STAFF REPORT

SUBJECT: FP-2021-0006
Pine 43 No. 4

LOCATION: 2255 E. Fairview Ave., at the northeast corner of N. Webb Way and E. State Ave., in the NW ¼ of Section 8, Township 3N., Range 1E.

B. Final Plat (dated: 2/11/21)

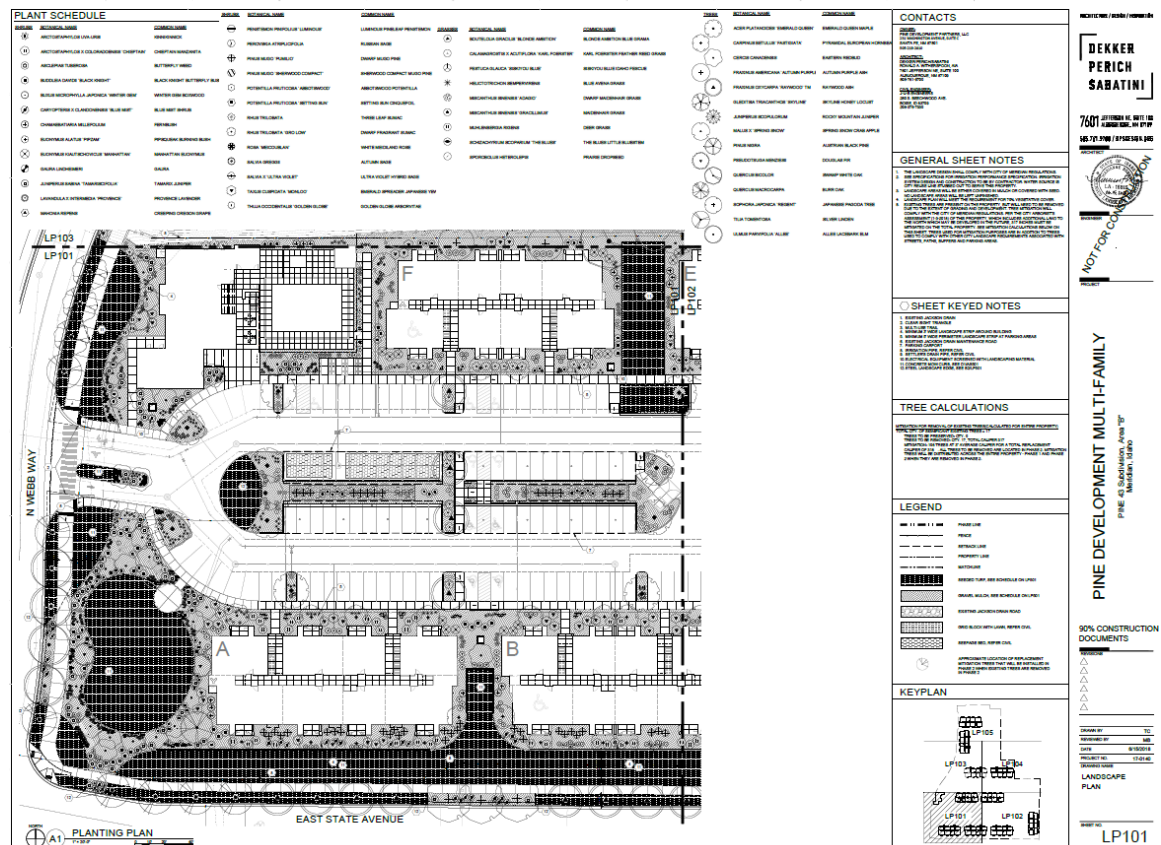
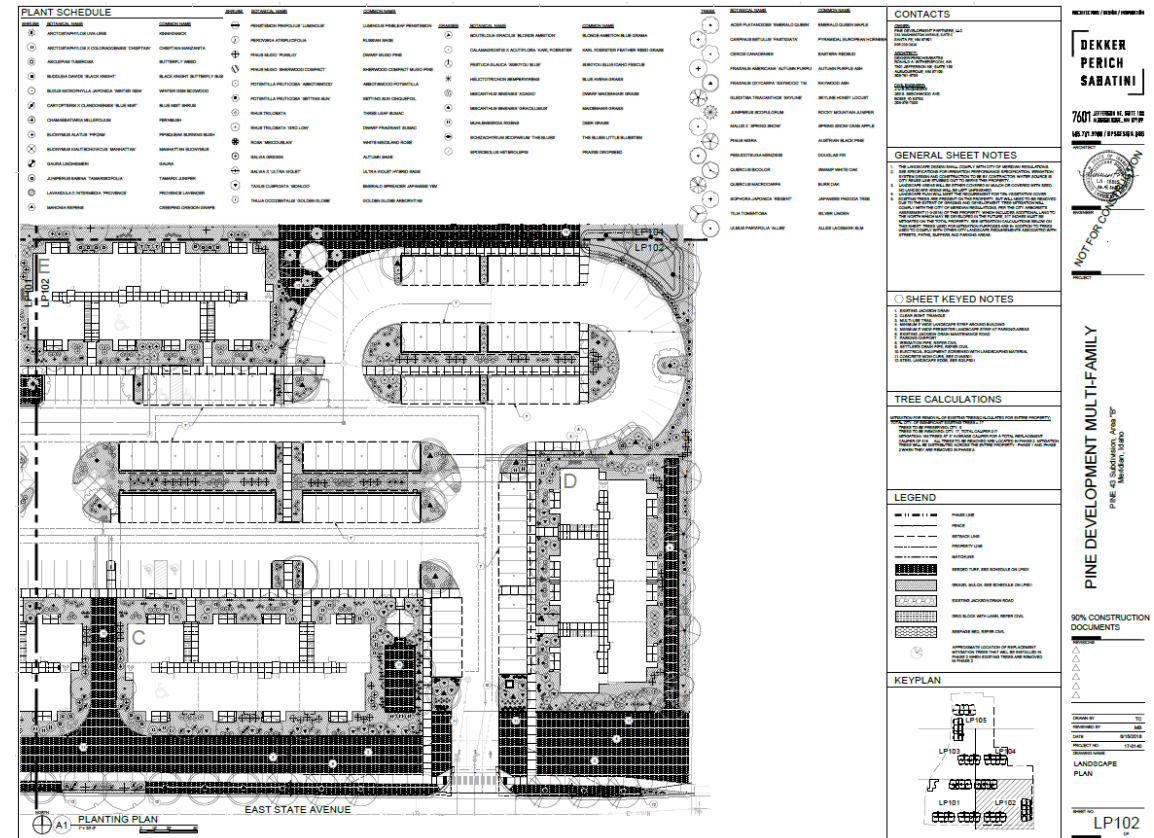
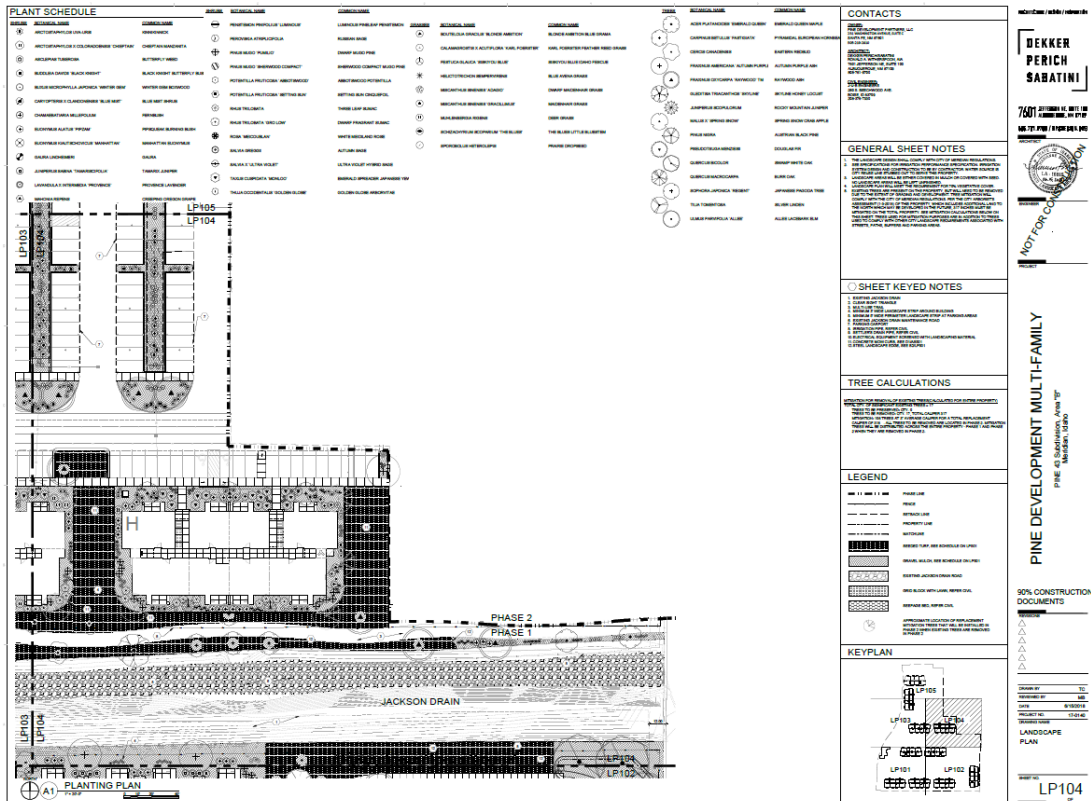
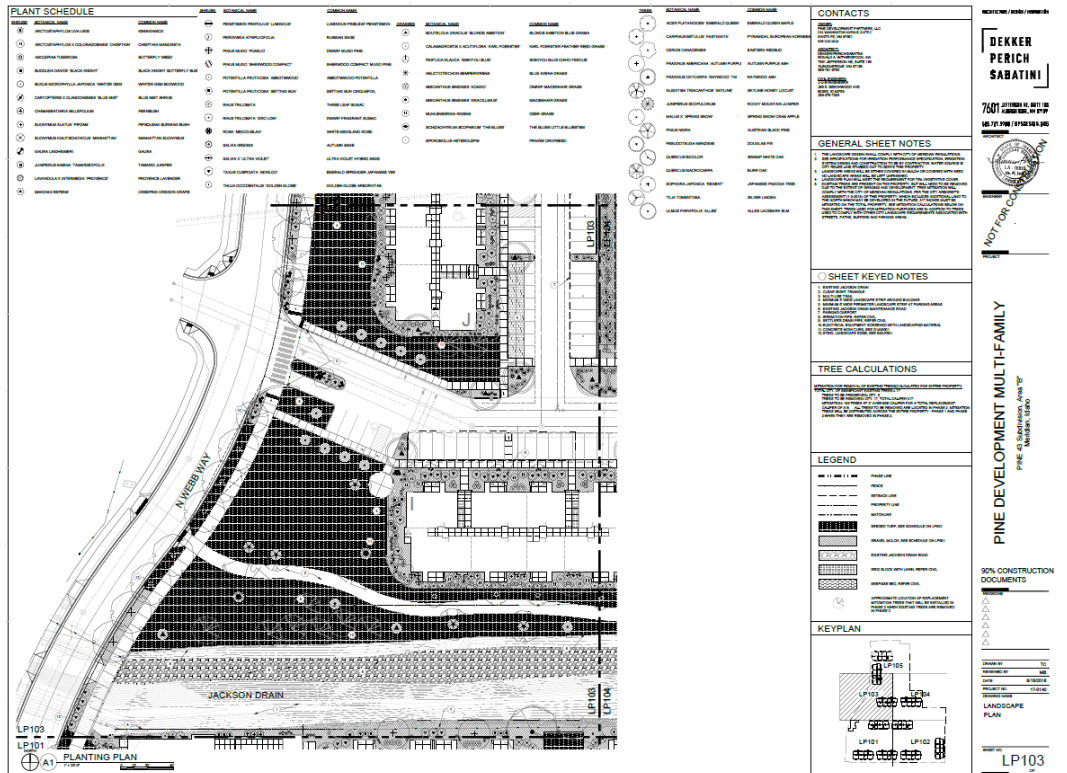
- a. Note #7: Include the recorded instrument number of the Development Agreement (#2018-000751).
- b. Note #8: Include the recorded instrument number of the ACHD License Agreement.

- c. Include a lot number for the common lot (i.e. street buffer) along with a note stating the common area will be maintained by the homeowners' association in accord with UDC 11-3B-7C.2a.
- d. The internal common open space and site amenities for the development shall be located on a common lot or an area with a common maintenance agreement as set forth in UDC 11-3G-3D.1.
- e. Depict a 10-foot (instead of 8-foot) multi-use pathway along the north side of the Jackson Drain as required by the Park's Dept. in accord with the Pathways Master Plan per H-2017-0058 (condition #1.1.2e).
- f. Depict 8-foot wide parkways along N. Webb Way and E. State Ave. consistent with that shown on the landscape plan.
- g. Depict NMID's easement for the Jackson Drain.

A copy of the revised plat shall be submitted for City Engineer signature.
